RE: St. Lucie Units 1 and 2
Docket Nos. 50-335 and 50-389
RAI Response for Addition of
Spent Fuel Pool Cask Pit Rack Amendment

RESPONSE TO
REQUEST FOR ADDITIONAL INFORMATION
CASK PIT RACKS LICENSE AMENDMENT REQUEST

ST. LUCIE PLANT, UNITS 1 AND 2

FIGURE 5
FUEL AREA SAFE LOAD PATH

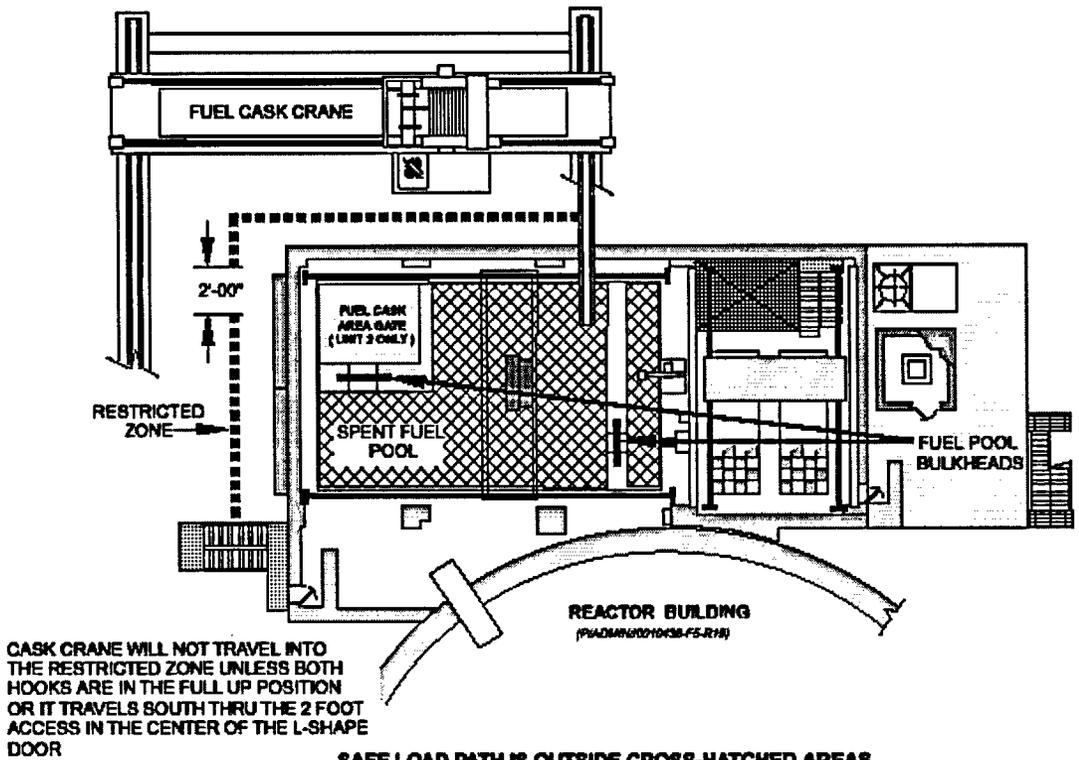
- (8) The submittal states that safe-load paths will be established for loads, specifically the spent fuel racks in and out of the cask pits. Explain the guidelines for establishing safe-load paths. In particular, address if the load could travel over spent fuel, any safety-related equipment, or any part of the spent fuel pool (e.g., weir wall).

The rack installations will follow the heavy load handling guidelines of St. Lucie Administrative Procedure 0010438, including the safe load paths established for the fuel handling areas depicted in Figure 5 of that procedure (a copy of which is attached). The Figure 5 safe load path for the cask crane on both units excludes the cross-hatched area over the entire spent fuel pool. As shown on Figure 5 and Unit 1 UFSAR Figure 9.1-15b, this load path restricts the crane main hook travel into the Fuel Handling Building to a two-foot-wide north/south corridor along the centerline of the L-shaped door opening into the building by the use of crane limit switches. The corridor terminates inside the fuel handling building at the approximate center of the cask pit. The objective of this restricted path is to allow crane access to the cask pit area while preventing the load from travel directly over spent fuel stored in the pool or the walls that separate the cask pit from the spent fuel pool. Because the cask pit rack is slightly smaller than the cask pit itself, the rack will be carefully lowered during installation to avoid contact with the cask pit walls.

When the cask pit rack is installed and contains fuel, the cask crane will be administratively prevented (blocked) from operating over the cask pit by use of a restricted area lockout keyswitch under the control of plant Operations. This lockout will protect any fuel stored in the cask pit rack from heavy loads and will prevent violating Technical Specification 3.9.7 weight restrictions over irradiated fuel.

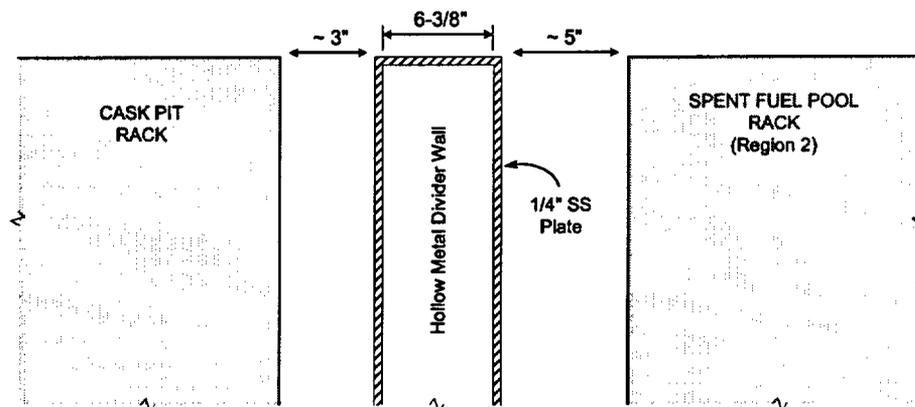
- (17) The current St. Lucie, Unit 2, spent fuel racks have a nominal 8.96-inch center-to-center distance between the fuel assemblies; however, the proposed amendment calls for a nominal 8.80-inch center-to-center distance between fuel assemblies placed in the cask pit storage rack. Please describe the basis for the reduced spacing and discuss how the change was accounted for in the reactivity calculations.

The Unit 2 cask pit storage rack cell pitch is less than the pitch of the current Unit 2 spent fuel racks because the new rack employs integral neutron absorbing material in the cell walls. The use of Boral panels between adjacent cells in the cask pit rack reduces the calculated k_{eff} for a given center-to-center spacing compared to the existing SFP racks.

The existing Unit 2 spent fuel storage racks do not contain either Boral or Boraflex neutron absorbing material. Reactivity control is achieved by use of (1) stainless steel L-inserts which provide some neutron absorption, (2) blocked-open cells (water gaps), and (3) the larger cell pitch (center-to-center spacing) identified in the Technical Specifications.

The Unit 2 cask pit rack reactivity calculation was based on the presence of Boral panels, an 8.80 inch pitch, and the related cell geometry depicted in Figure 4.2.2 of Enclosure 2 to the submittal.
